SUNDRY NOTICES AND REPORTS ON WELLS
(DO NOT USE THIS FORM FOR PROPOSALS TO DRILL OR TO DEEPEN OR PLUG BACK TO A DIFFERENT RESERVOIR. USE "APPLICATION FOR PERMIT" (FORM C-101) FOR SUCH PROPOSALS.)

For:	Catherine Isaly	Page:	1
Company:	DGOC	API#:	30-021-20667
Subject:	Lewis 2028 35-1 P&A	Date:	7/6/2026
Location:	Harding Co., NM	By:	Ben Gifford

PROPOSED P&A WBD
6/15/2026

Operator: BREITBURN OPERATING LP 500 Dallas street, Suite 2300 Houston, TX 77002	OGRID: 370080
	Action Number: 602250
	Action Type: [C-103F] NOI Plug & Abandon (C-103F)

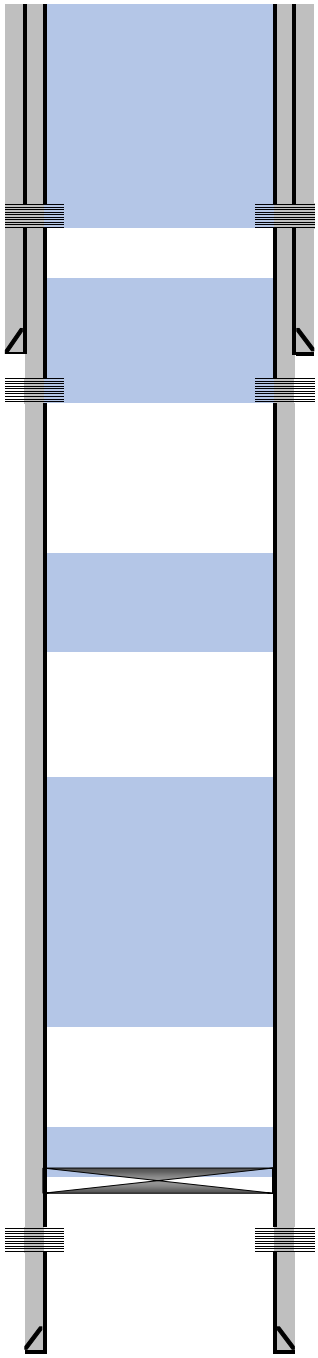
Created By	Condition	Condition Date
loren.diede	Notify the OCD inspection supervisor via email 24 hours prior to beginning Plug & Abandon (P&A) operations.	7/20/2026
loren.diede	Monitor all string pressures including Bradenhead daily and report those findings on Subsequent Report.	7/20/2026
loren.diede	A CBL log must be run and submitted to NMOCD for evaluation after the CIBP has been set at 2638' and prior to commencing with the plugging.	7/20/2026
loren.diede	See attached COAs regarding the P&A marker requirements.	7/20/2026
